Addendum 1
Solicitation 21-99547
Brighton Beach Trail Relocation

This addendum serves to notify all bidders of the following changes to the solicitation documents:

REALIGNMENT PLAN FOR LAKEWALK EXTENSION:

PROPOSED TYPICAL SECTION
NO SCALE

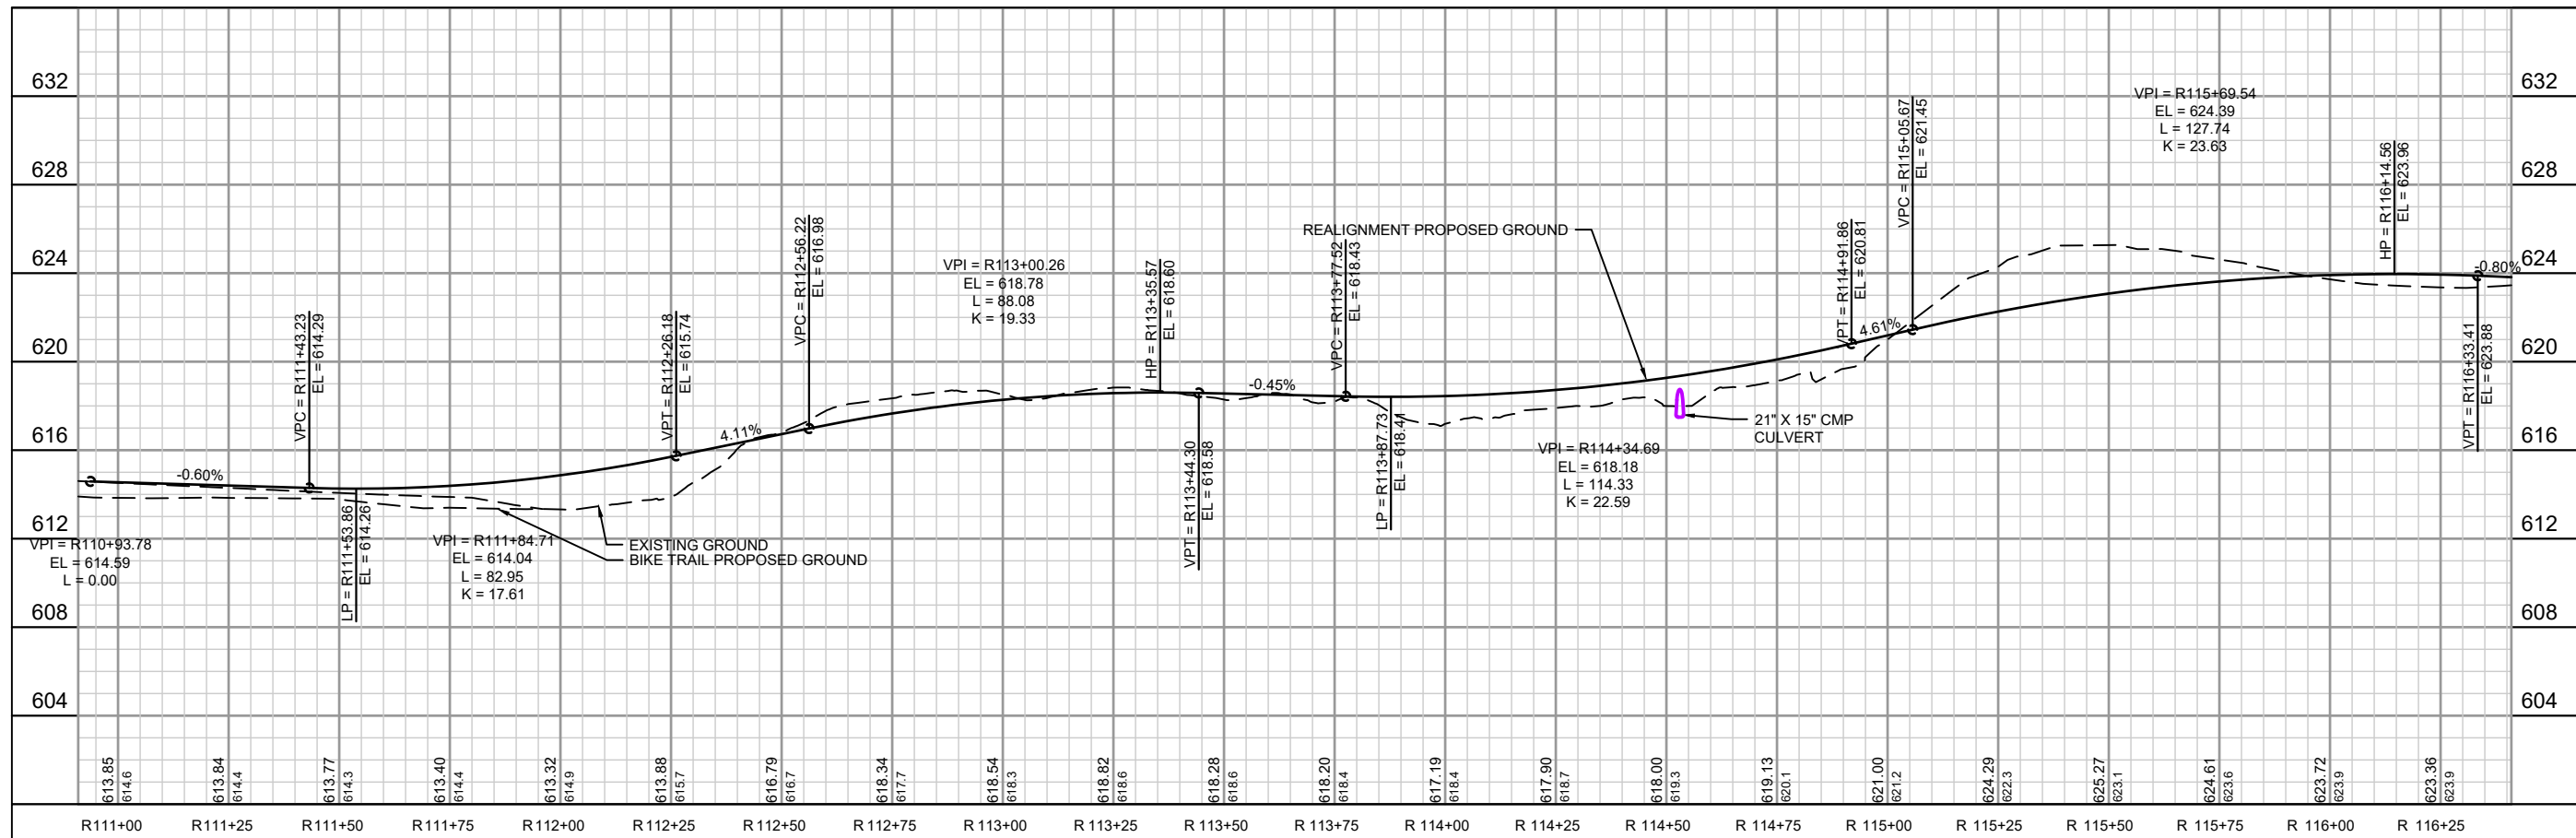
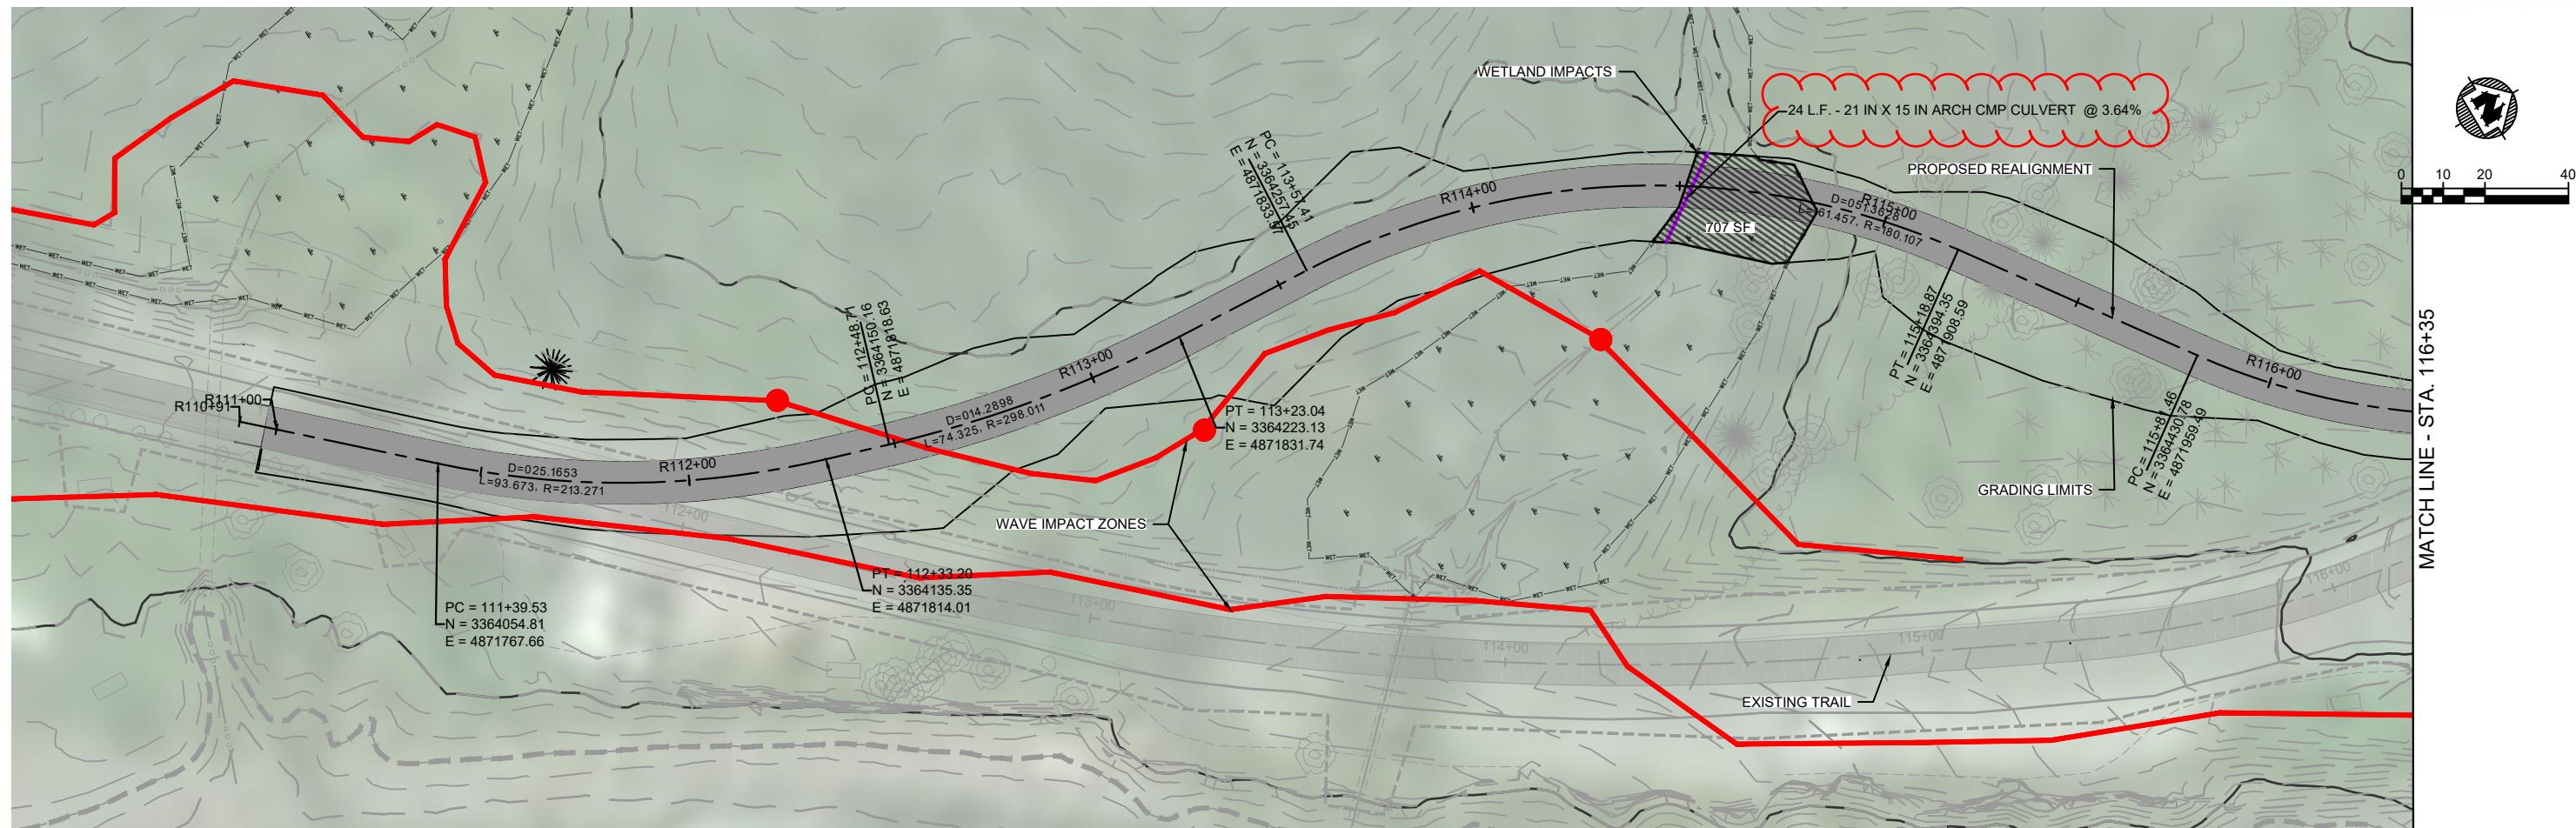
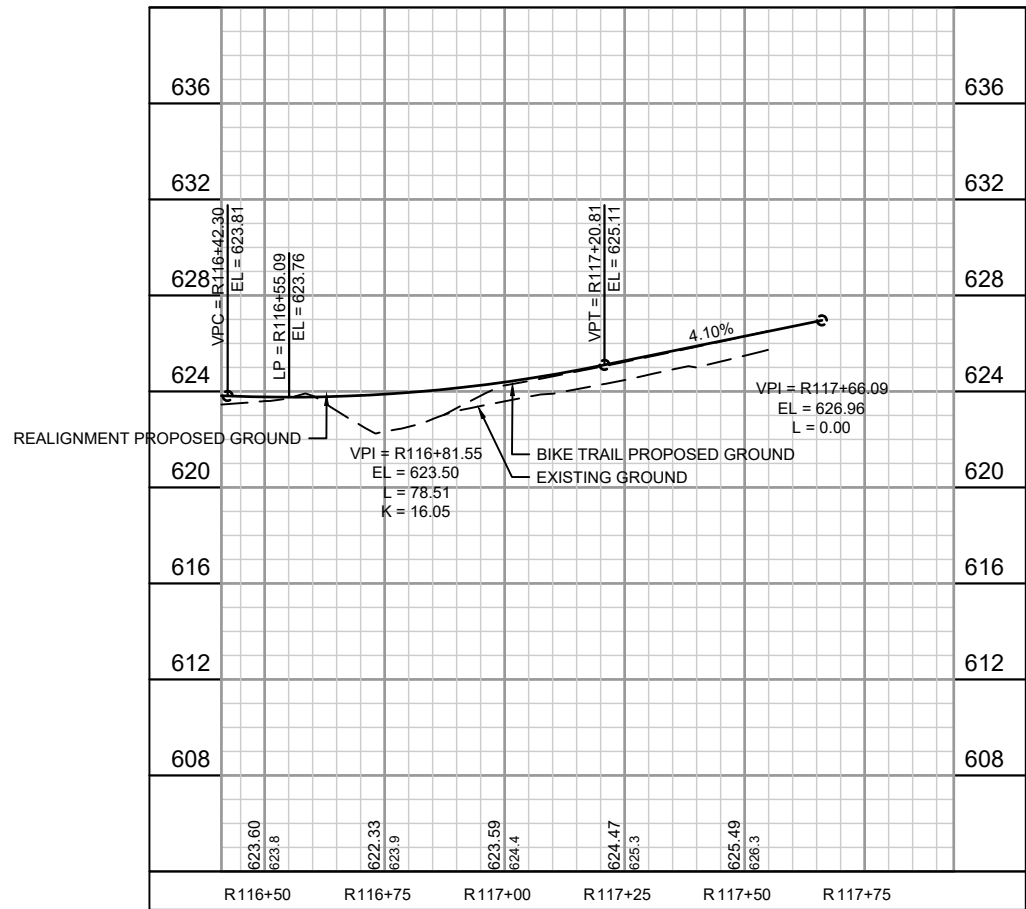
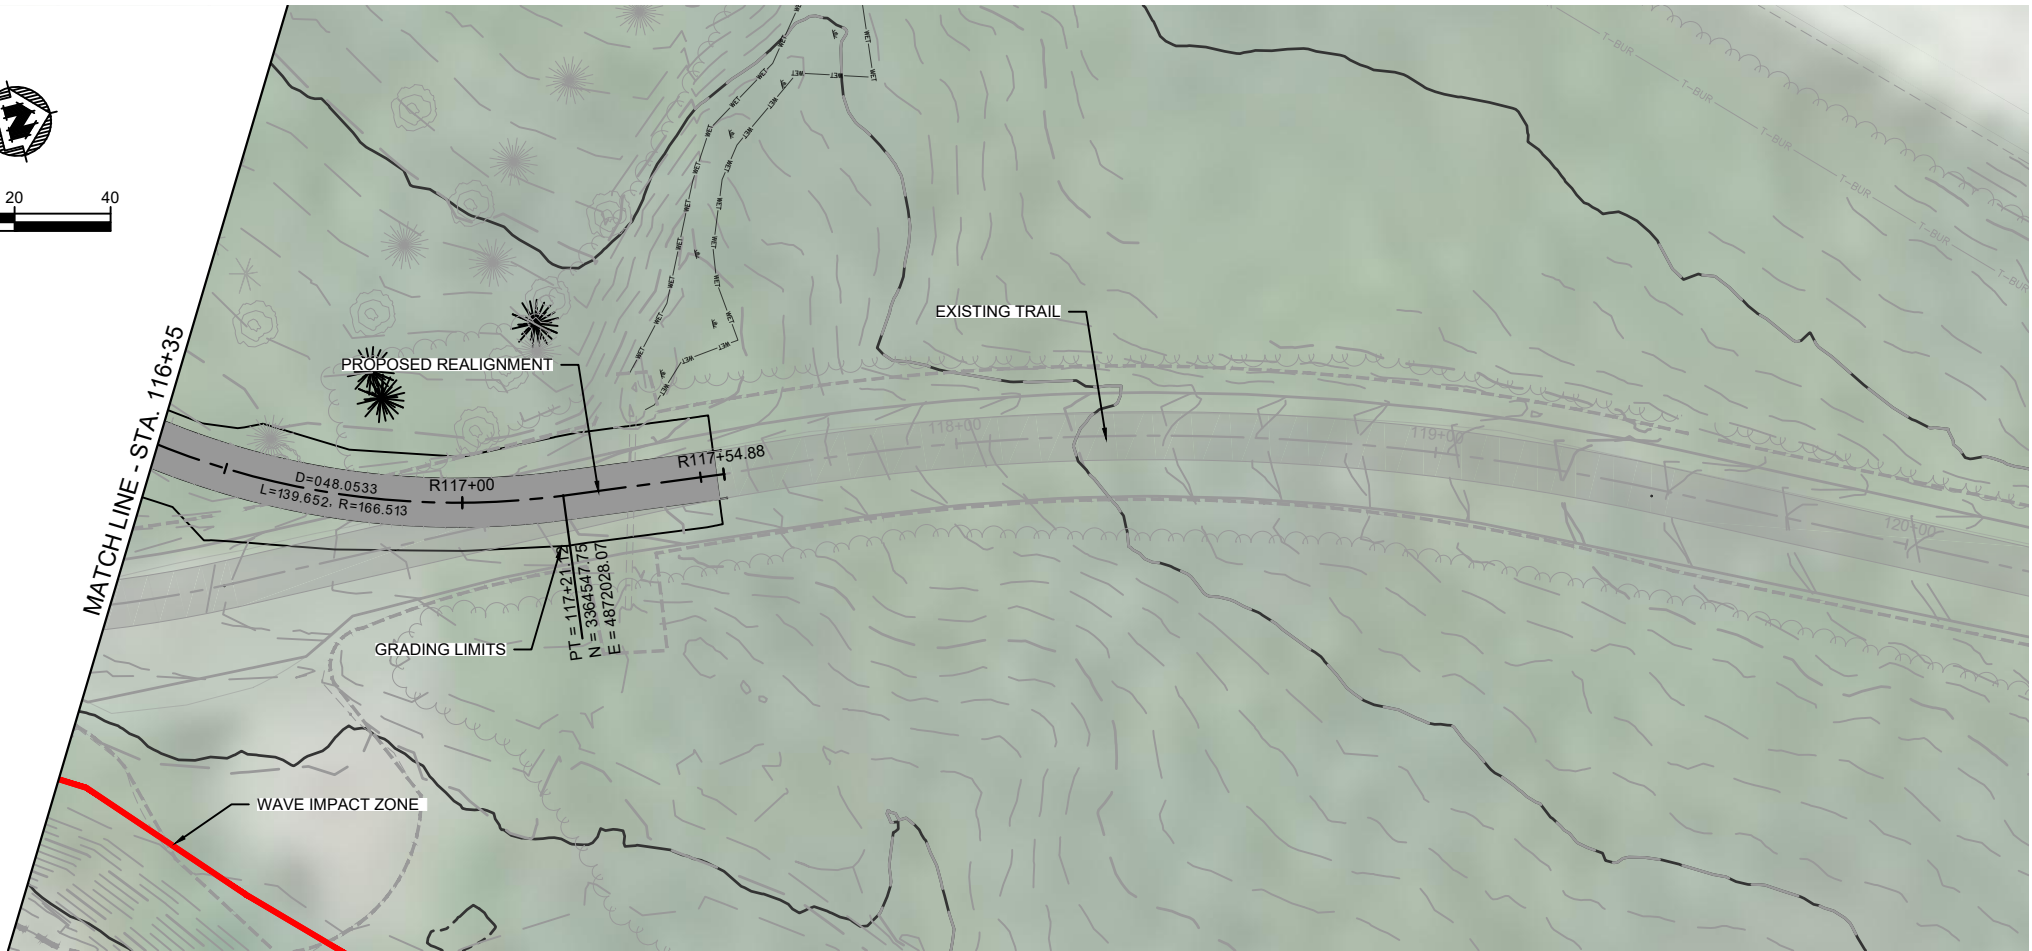
1. The pre-bid meeting sign-in sheet is attached.
2. A revised planset is attached. Changes to the plans are as follows:
 - a. Trail alignment and profile have been modified
 - b. Cross sections reflect the new alignment and profile
 - c. The CMP arch pipe is 21 in x 15 in
 - d. The Statement of Estimated Quantities chart has been updated
